Your Ref SSD-10416

**COUNCIL SUBMISSION
NOTICE OF EXHIBITION OF MODIFICATION REPORT NO. 2 FOR THE PARRAMATTA
POWERHOUSE (30B PHILLIP ST, PARRAMATTA)**

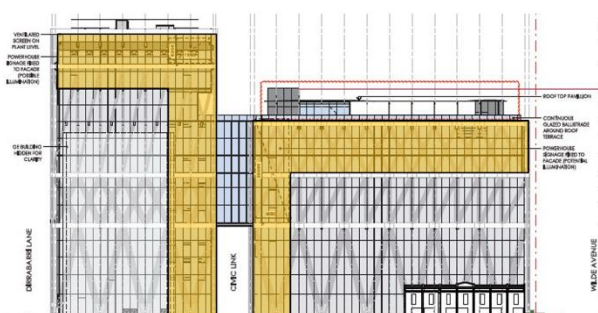
The approved rooftop canopy on the western building was discretely set back from the building parapet, creating a solid visual termination of the building. The solid frame of the approved rooftop canopy, made prominent by its shadow lines, provides design resolution to the building (see figure below). It is considered an integral part of the original design and contributes significantly to the building character. The revised design does not include this solid frame, but rather has open sides with varied plant behind, which is considered a design compromise, not a design improvement. As such it is recommended that a more solid frame be retained.

Original façade design

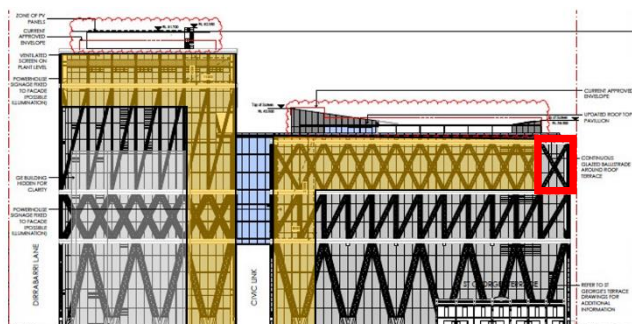
The amendment to the level 3 building façade is not supported; whilst it is noted that the GRC panelling is consistently used throughout the rest of the building, the proposed change results in a poorer façade composition. The diagram below, highlighted in yellow, delineates a consistent glazed ribbon in a logical pattern across the facades, that is interrupted by the proposed modification (see below in red). It is recommended that the glazing is not replaced by GRC panelling. Hiding of servicing and plant could occur behind the glazed element.
